EBEY'S LANDING HISTORIC PRESERVATION COMMISSION
ISLAND COUNTY COMMISSIONERS' HEARING ROOM (Room 102B)
1 NE 6th St., COUPEVILLE, WA
AUGUST 28, 2025

Ebey's Landing National Historical Reserve
Certificate of Appropriateness
Connor Tasoff
304 NE Fifth St
COA-25-028

Ebey's Landing National Historical Reserve
Certificate of Appropriateness
Wood
433 Wanamaker Road, Coupeville
EBY-25-023

AFTER-THE-FACT REMODEL; CONDITIONS OF APPROVAL UPDATE

3/4" = 1'-0"
 Existing East, South & West Elevations
 Proposed East, South & West Elevations

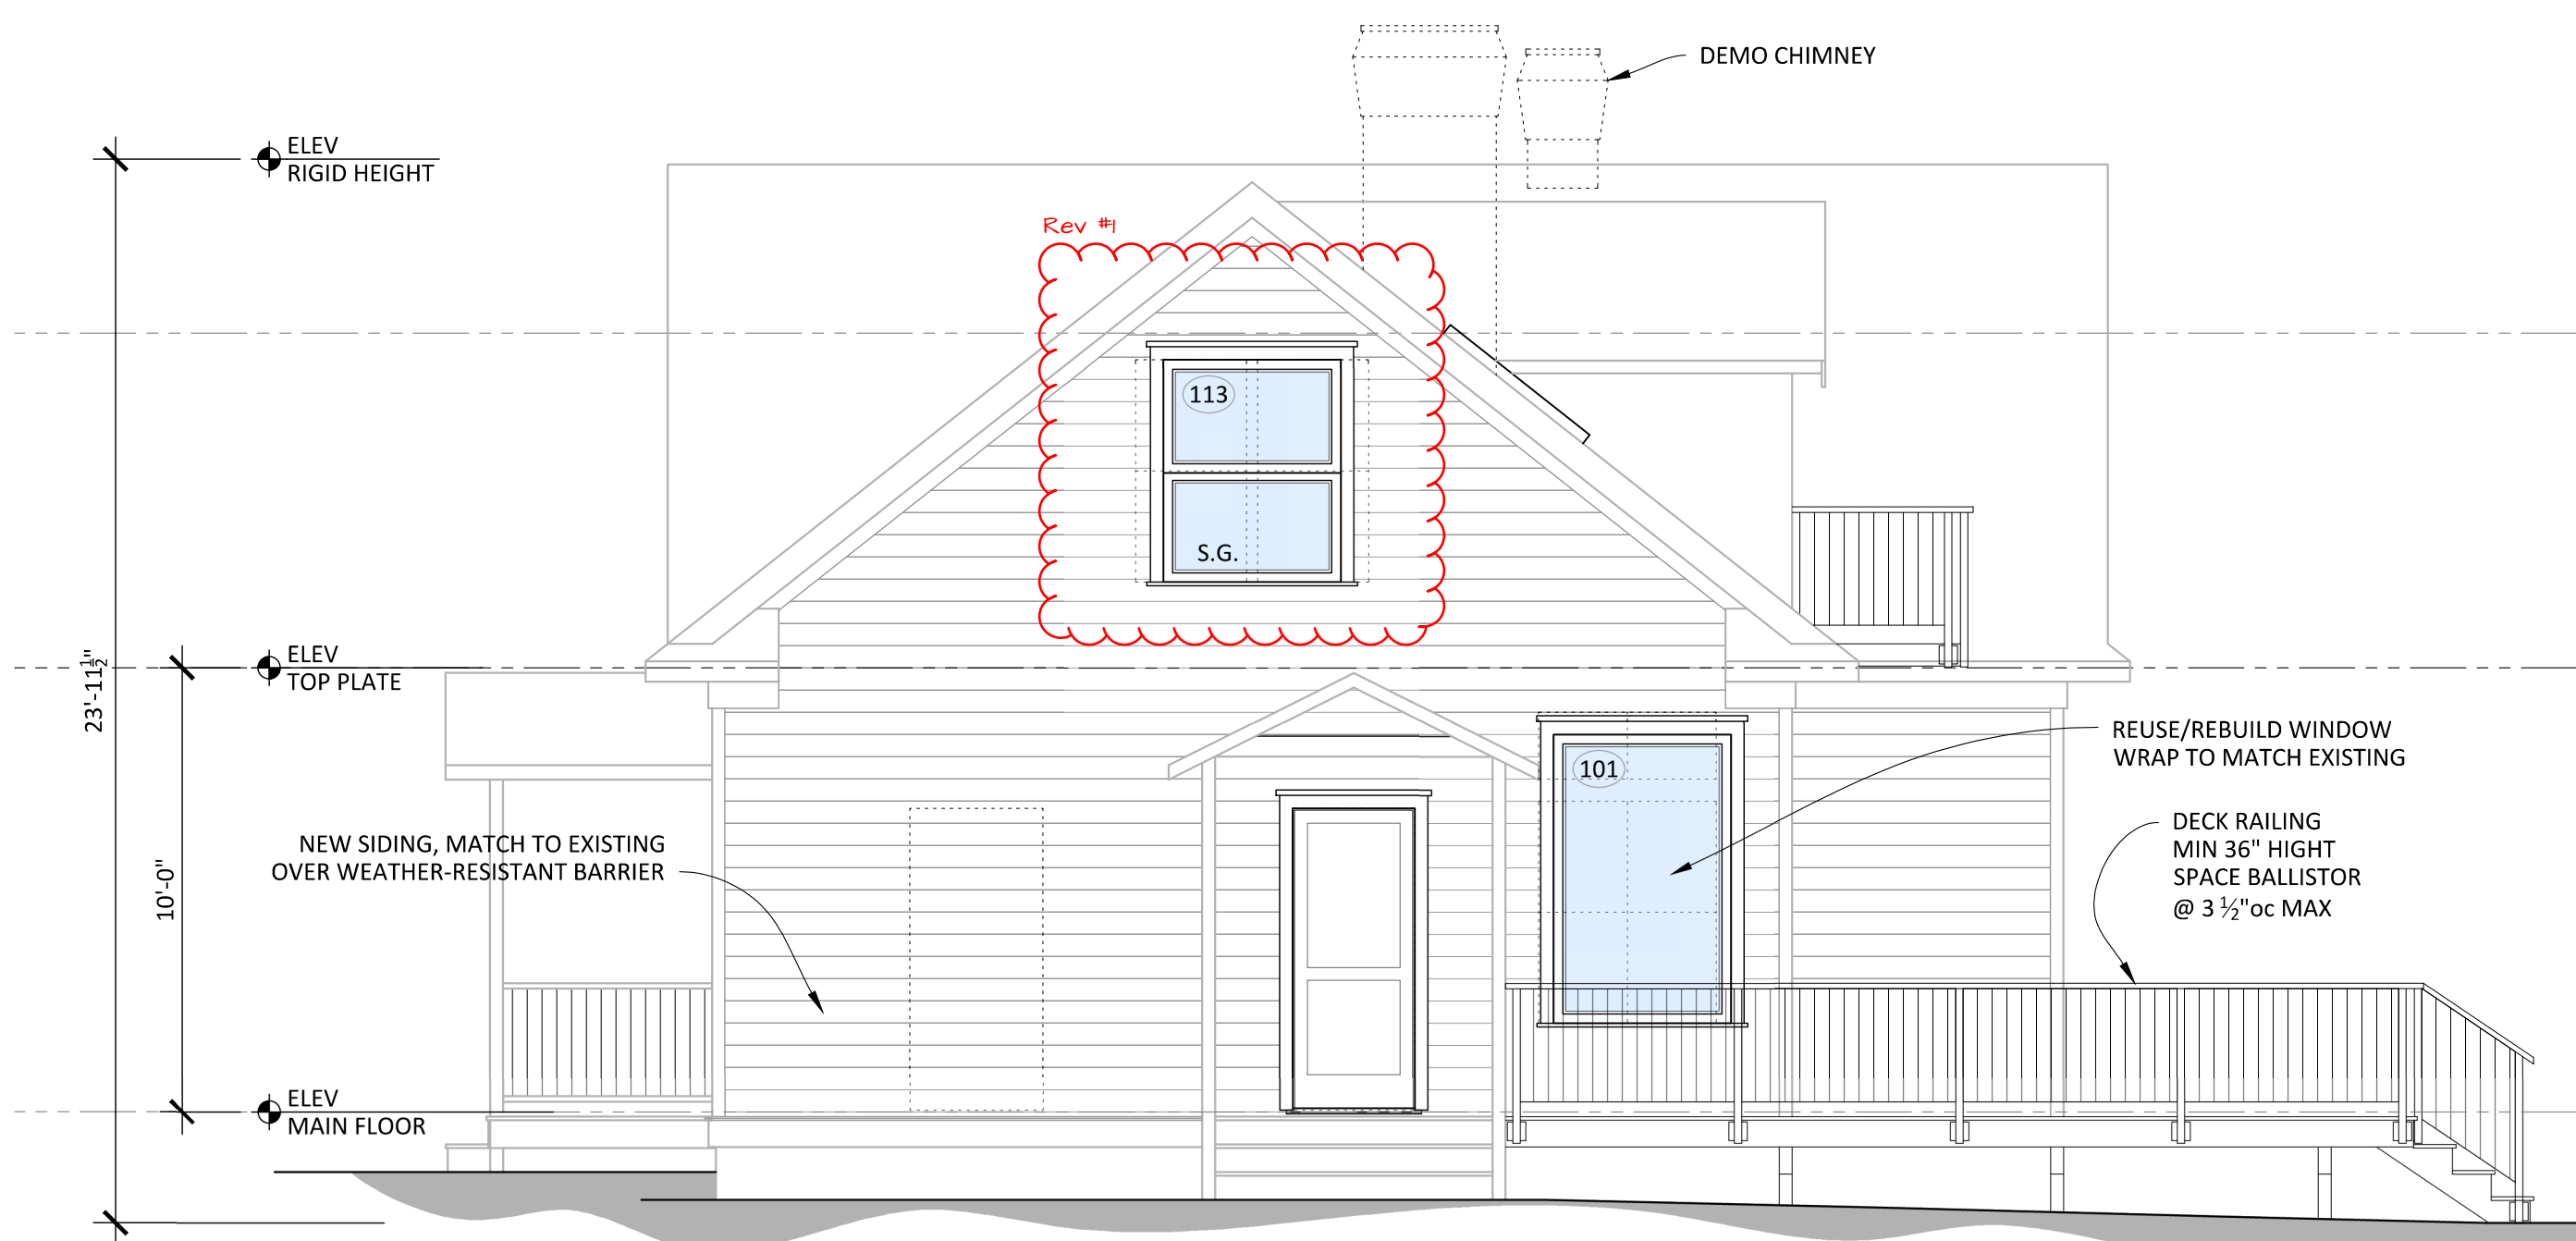
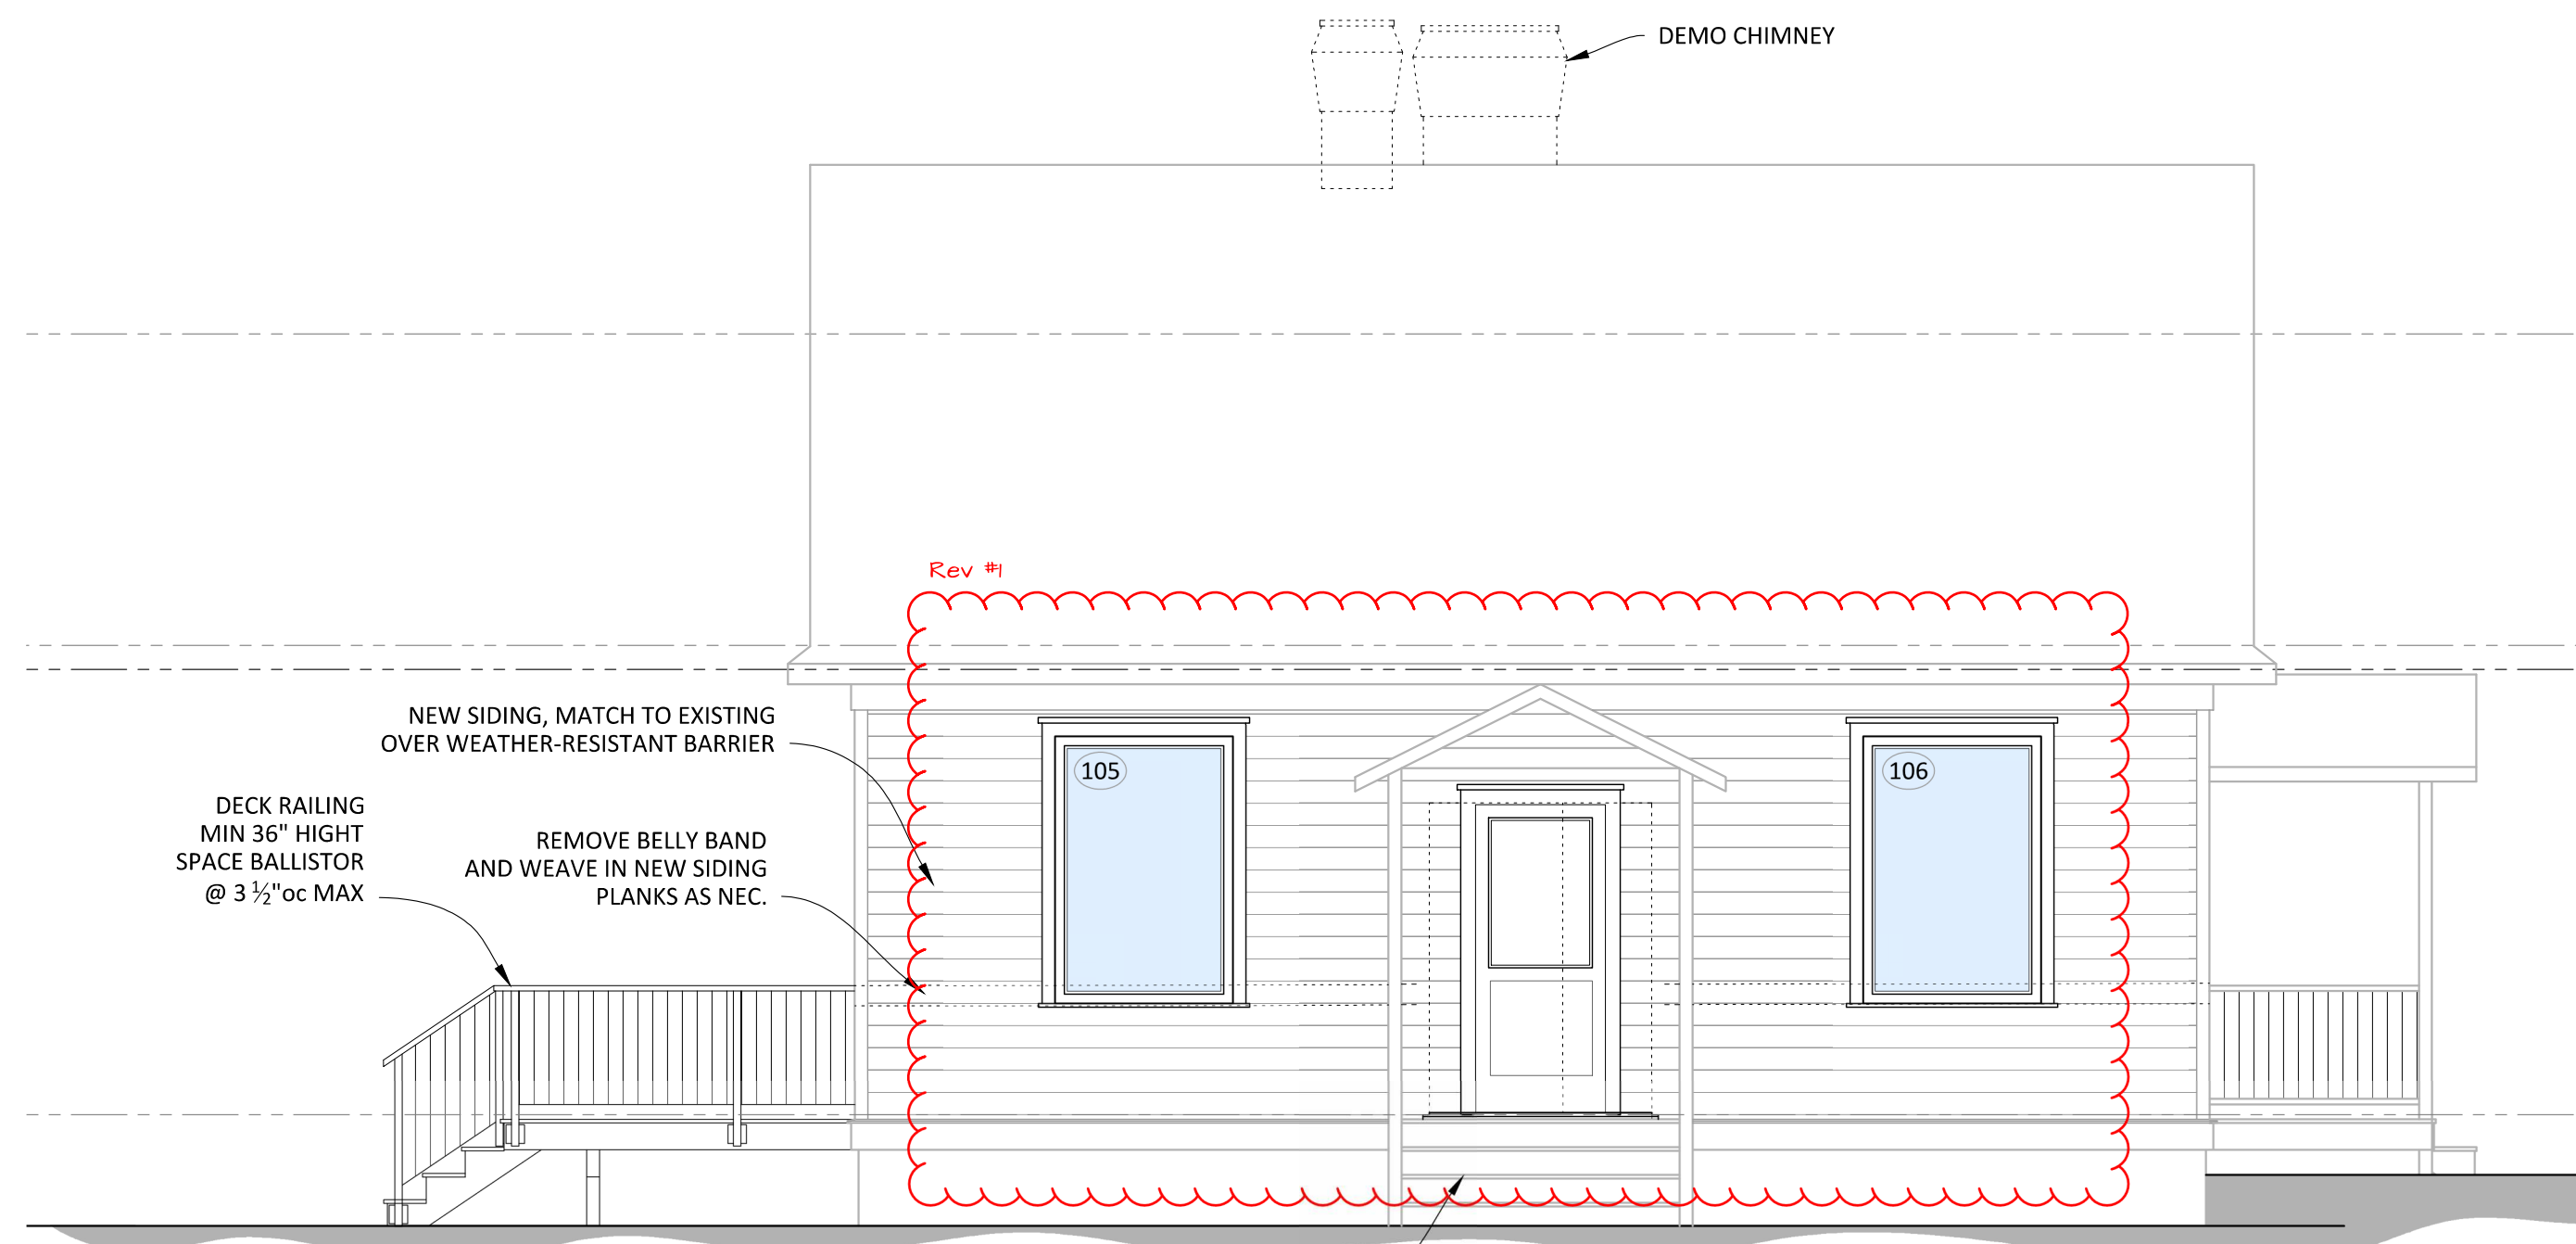
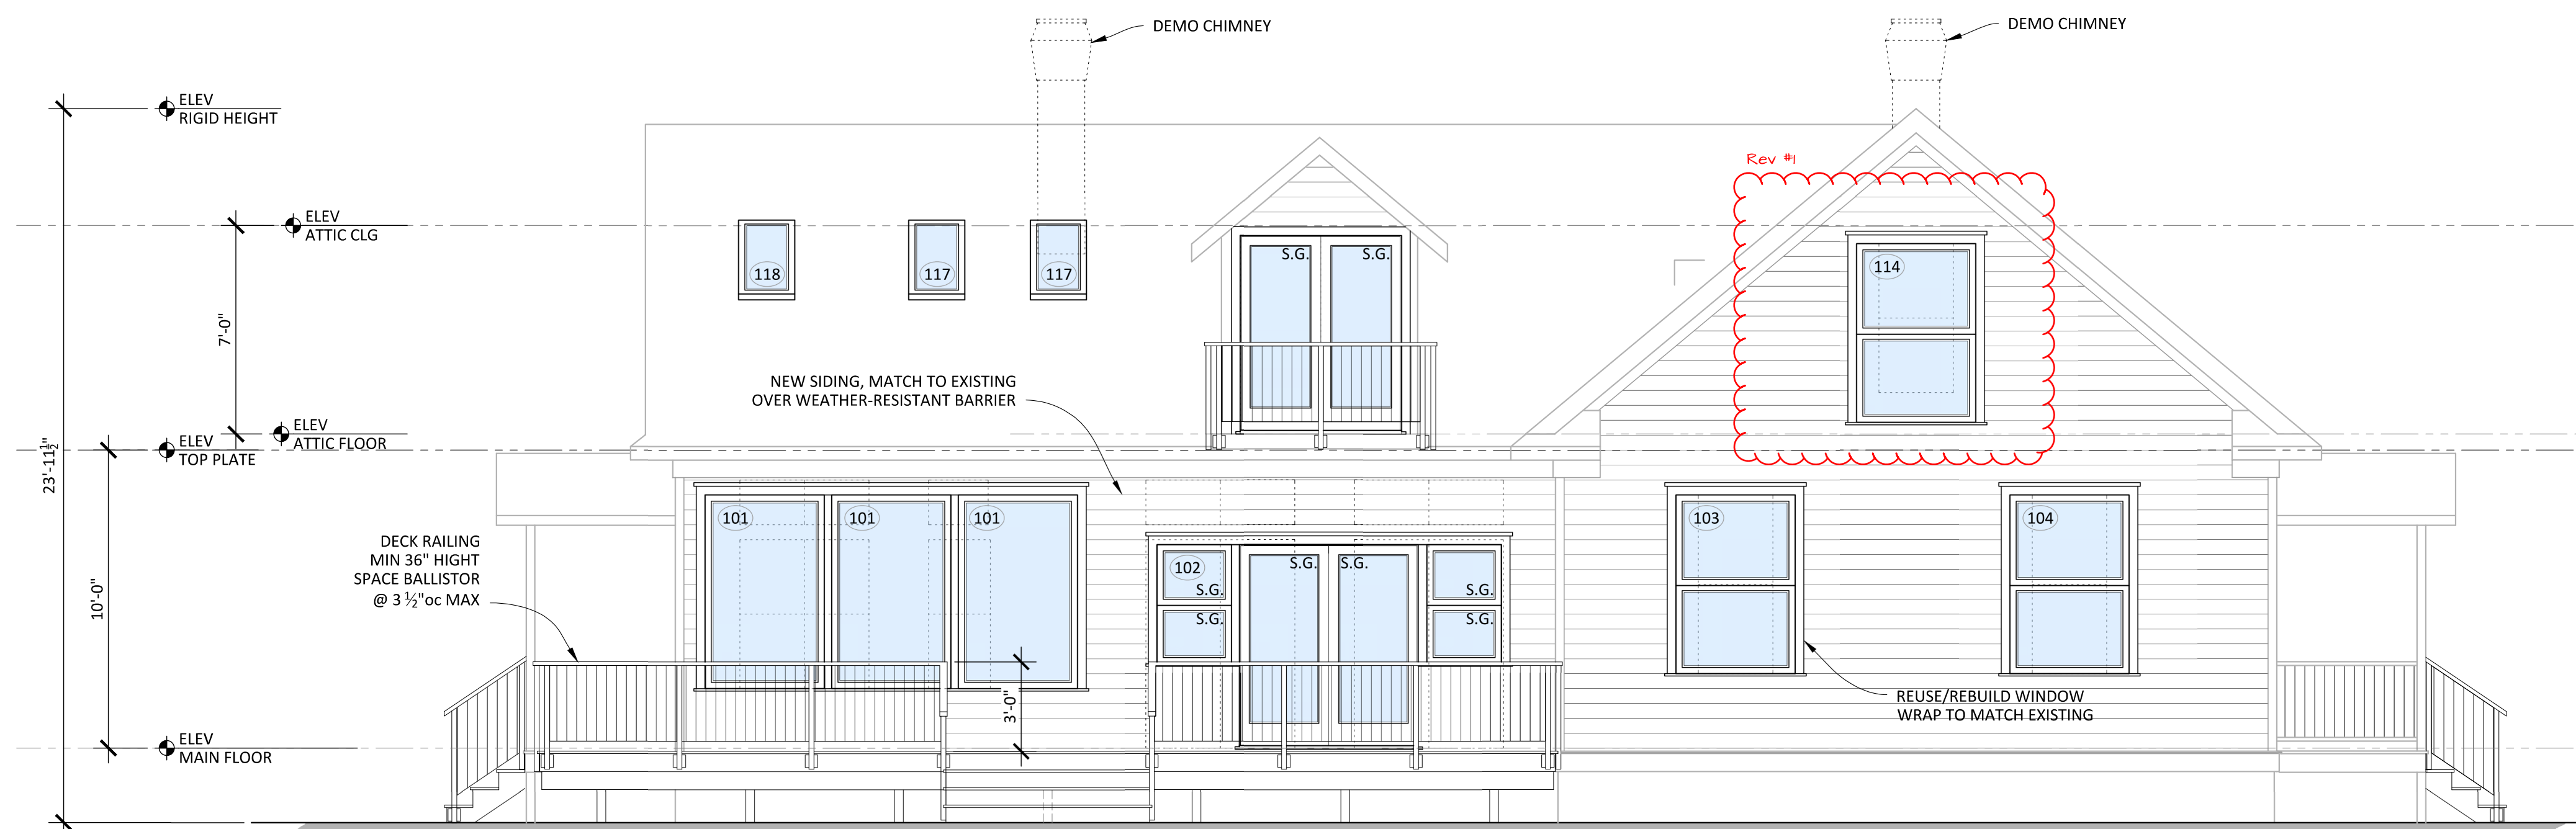
1. The bellyband on the eastern and western façade must be removed.
2. The windows of the eastern façade must be restored to its original dimensions.
3. Reinstall the previous doors of the eastern façade or reframe the opening by removing the sidelight.

On August 14, 2025, the applicant provided updated elevation plans that satisfy the conditions of approval approved by the Historic Preservation Commission.
